Subject: River Bend Station
Docket No. 50-458
License No. NPF-47
Additional Information Related to License Amendment
License Amendment Request (LAR) 99-15, Changes to Technical Specifications
for Power Uprate of River Bend Station

Response to NRC Questions Related to River Bend Station Power Uprate Amendment

Enclosure 2
Response to NRC Questions Related to River Bend Station Power Uprate Amendment
(TAC NO.MA6185)

Figure H-8 DBA-0.1 ft³ Steam Break, Long-Term Drywell, Suppression Pool and Containment Airspace Temperature. 102% Up-rated Power/ 100% Rated Core Flow, (SHEX-04V)

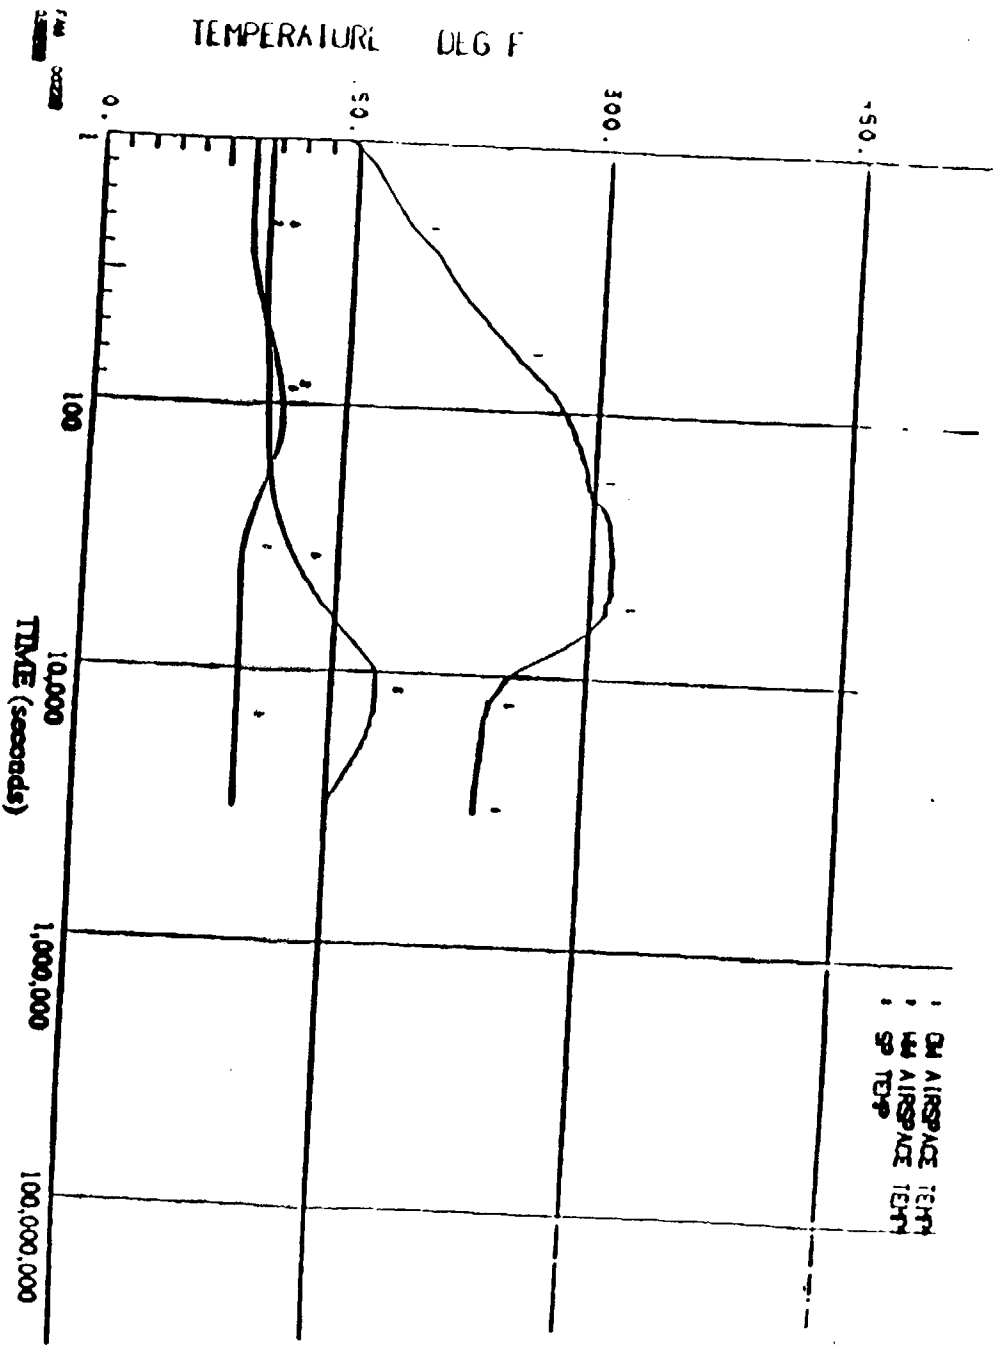
Question 5: Please provide the containment analyses maximum pressure and temperature curves at uprated power after a LOCA. Discuss the limiting initial conditions assumed for the DBA LOCA and for the sensitivity case for the MSLB for peak drywell pressure as indicated in Section 4 1.1.3. Also provide the containment drywell pressure limit in psig.

Response 5: Drywell & Containment Pressure Temperature Plots are attached at the end of this response. Please note that these figures are considered GE proprietary information. The original USAR analysis was based upon a nominal set of initial conditions. These results were supplemented by a sensitivity analysis to establish the range of acceptable conditions for the containment (Technical Specifications 3.6.1.4, 3.6.1.5, 3.6.2.1, 3.6.5.4, and 3.6.5.5). The following table summarizes the initial conditions, and key results for the nominal case, and significant sensitivities.

In the table above, the peak drywell temperature is shown to exceed the design limit by approximately 3 °F. This is discussed in Section 4.1.1.3 of NEDC-32778P. The computer program used to calculate the short term response does not include the impact of heat sinks on the temperature rise. If heat sinks are considered, the peak drywell temperature will not exceed 330 °F.

The current value of P_a used for containment testing is 7.6 psig, and is based upon the containment response assuming Technical Specification initial conditions. This value of P_a bounds the peak containment pressure calculated for uprate. Therefore, the value of P_a for containment testing will remain 7.6 psig.

HYDROGEN CONCENTRATION VS TIME AFTER LOCA

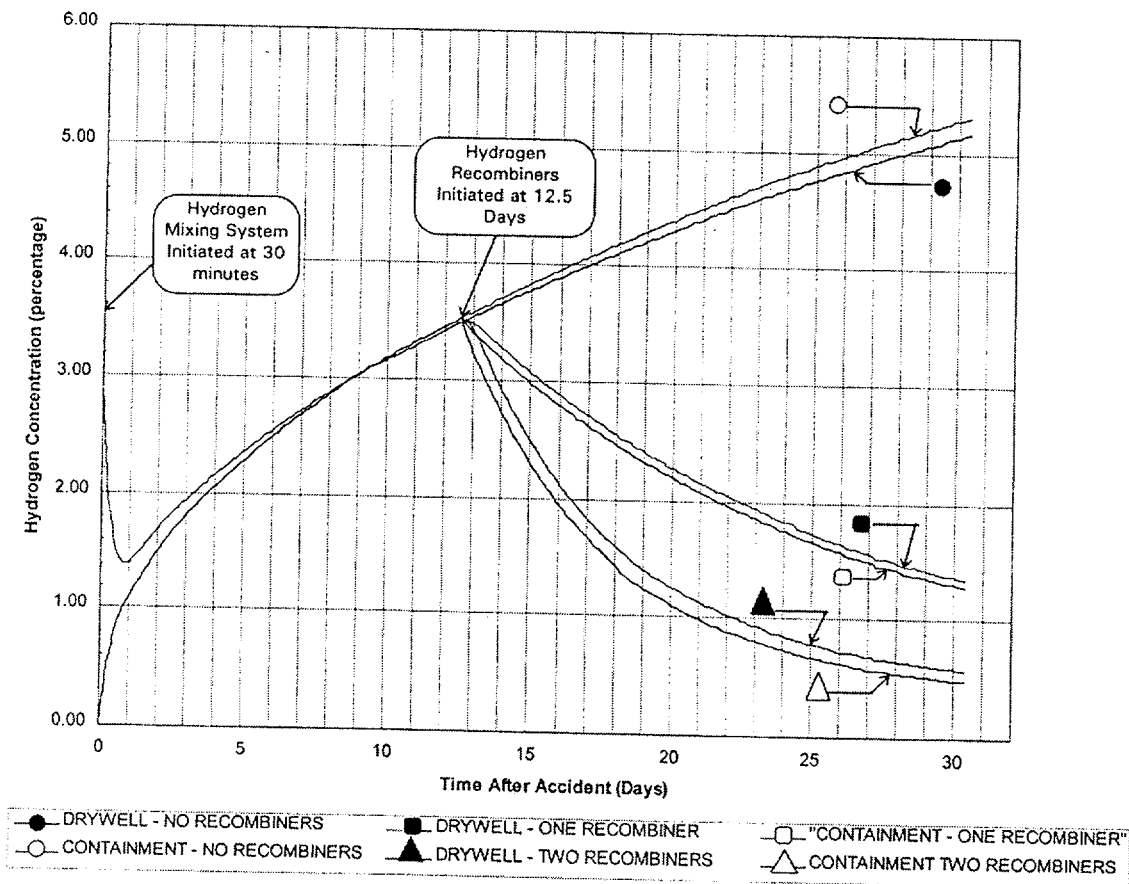
Question 6: In Section 4.7 for Post-LOCA Combustible Gas Control, it is indicated that post-LOCA production of hydrogen and oxygen from radiolysis increases proportionally with the power level. Please provide the hydrogen and oxygen generation rate Volume % vs. time curves after a LOCA and indicate the effect on the start-up time of the recombiner to keep the hydrogen level below the flammability limit at uprate power compared to current power level.

Response 6: The radiolytic source term change, which is directly proportional to thermal power, was accounted for in the calculation. The hydrogen generation rate is dominated by Metal Water Reaction at the beginning of the accident (i.e. short term hydrogen control). The contribution from radiolysis becomes significant a few days after LOCA, when recombiners are needed to mitigate the H₂ concentration in the containment. The predicted start time of the recombiners after uprate is on the order of 12 1/2 days, a shorter time comparing to the pre-uprate recombiners start time of 14 days. The following is the hydrogen vol. vs. time curve:
